# TOWN OF PLAINFIELD DESIGN REVIEW COMMITTEE REPORT

**DATE:** 11-09-2023  
**CASE NO.:** [Not Docketed](#)  
**PETITIONER:** Innovative Engineering  
**REQUESTED ACTIONS:** Development Plan Amendment - Architectural and Site Design Review for a façade renovation and 26,000 sq ft building expansion  
Waivers – Building Materials  
Development Incentives – Orientation of Loading Spaces

**LOCATION:** 2733 E. Main St.  
**PARCEL SIZE:** 25 acres+/-

Approved Landscape Plan (2012)

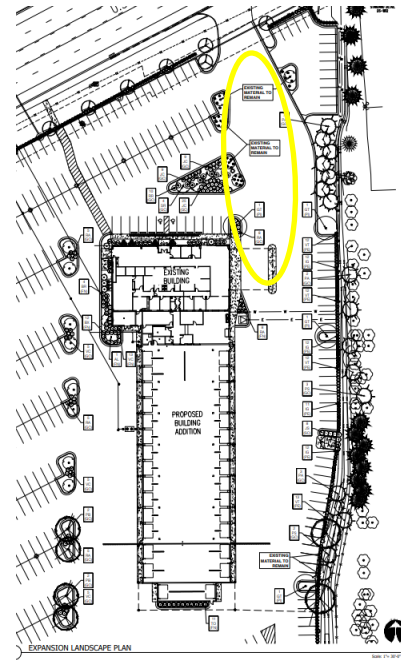
Staff review of the approved site and landscape plans indicates that the developed property differs in certain aspects. The site was developed in phases, with a portion being developed in 2012 and an expansion in 2018. This resulted in certain modifications to the initial plan including the relocation and reduction of a substantial parking lot island and placement of trees at the edges of the lot. The proposed site plan for the building renovation and expansion includes additional landscape island removal as shown in yellow below. Part of an existing island on the north side of the building would be expanded and new islands will be added west of the building and along the east side of the parking lot.
